Docket Nos. 50-321, 50-366
License Nos. DPR-57, NPF-5
EA 94-064

SUBJECT: ENFORCEMENT CONFERENCE SUMMARY
(NRC INSPECTION REPORT NOS. 50-321/94-09 AND 50-366/94-09)

LOSS OF SHUTDOWN COOLING HATCH UNIT 2

TITLE: VESSEL ONLY BOIL-OFF TIME

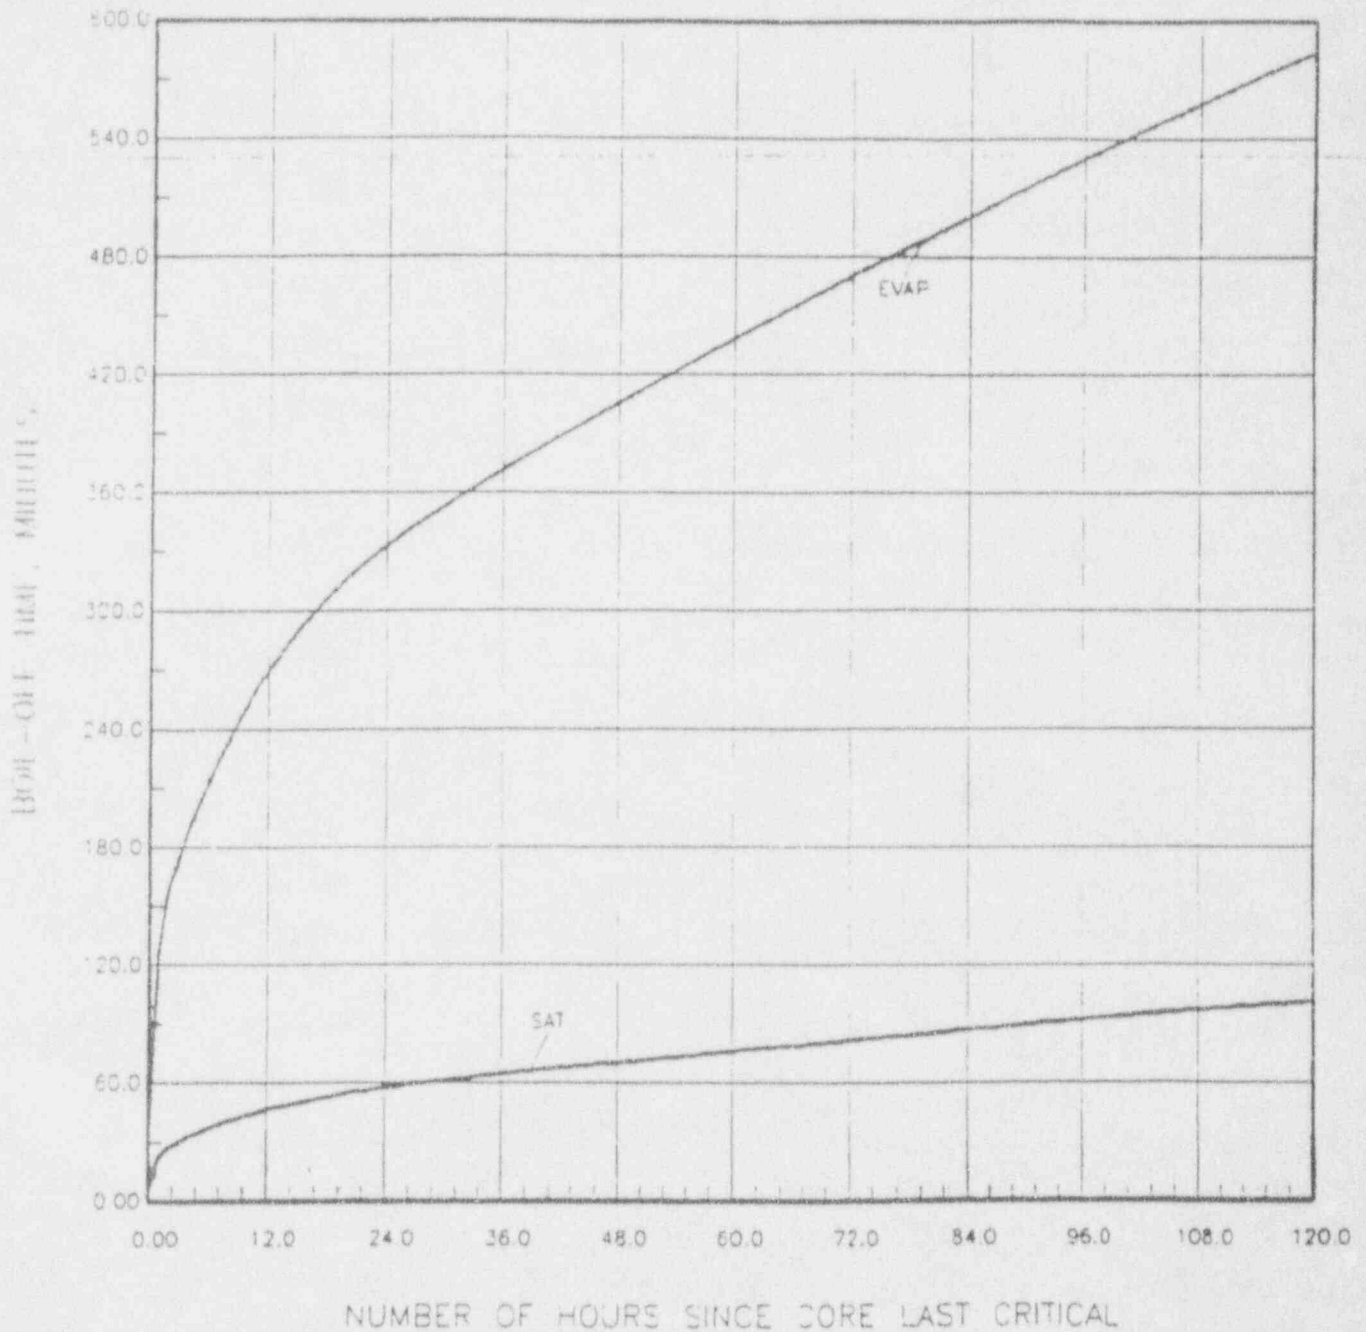
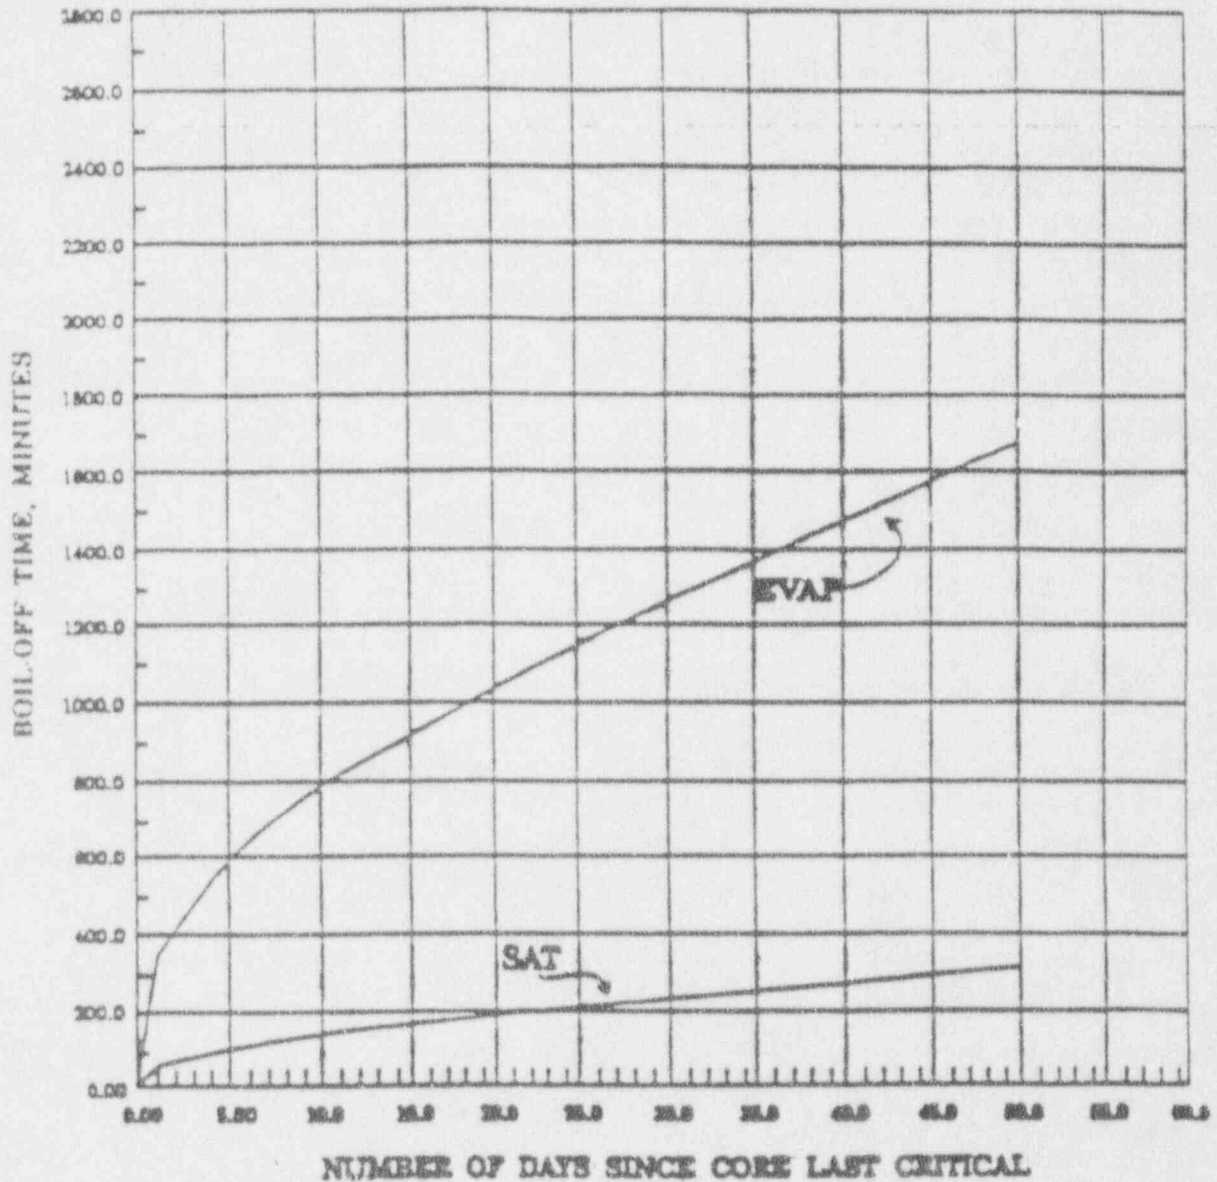
From Inspection Report: "...graph is difficult to use as a reference."

The graph in the Operations procedure was usable. However, the graph has been enhanced in the procedure to make it more user friendly.
